PUBLIC UTILITIES COMMISSION

SUBJECT: General Order 112-E Audit of PG&E's Peninsula Division

Re: State of California – Public Utilities Commission
General Order 112-E Inspection – Peninsula Division

District Regulator Station Maintenance Record

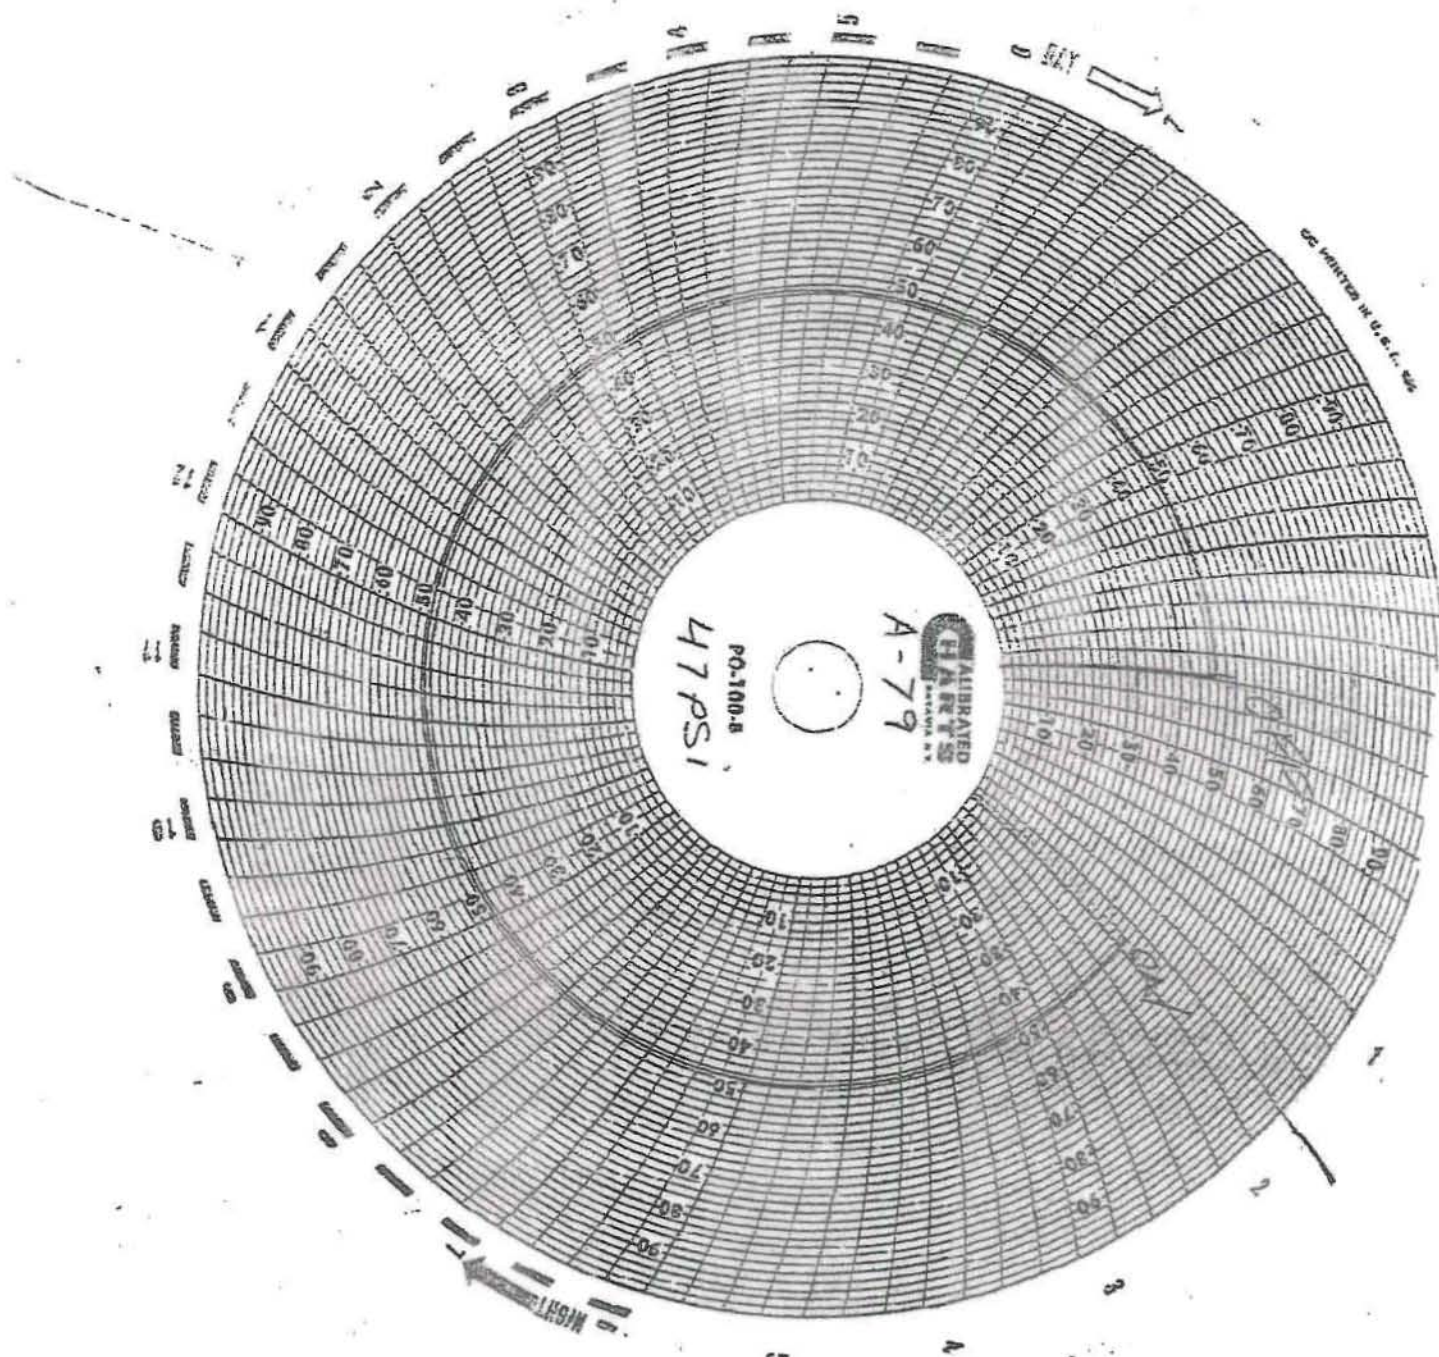
1. During the field inspection at regulator station A-79, the monitor did not take over. The inspection of the regulator station was stopped prior to the downstream pressure exceeding MAOP + allowable. The monitor was then reset at a lower pressure and it then took over. Please ensure that regulator station devices are set to the appropriate set points in order to protect against over pressuring.

For the record, the monitor set point for Regulator Station A-79 was appropriate at the time of the USRB audit (52 psig). However, as you note, during the audit, the monitor did not take over and the monitor was reset at a lower pressure (47 psig).

Subsequently, an internal inspection of the regulator station was performed on July 22, 2008. (See attached documentation.) A full class "B" maintenance inspection was performed. The monitor was torn down, all rubber goods were replaced, monitor was cleaned, reassembled and reinstalled. No problems were observed during the inspection. The monitor regulator was tested and observed to control at 52 psig at the completion of the inspection.

We have inspected and maintained the monitor to ensure proper operation. (See Attachment E – Regulator Station A-79 Maintenance Record.)
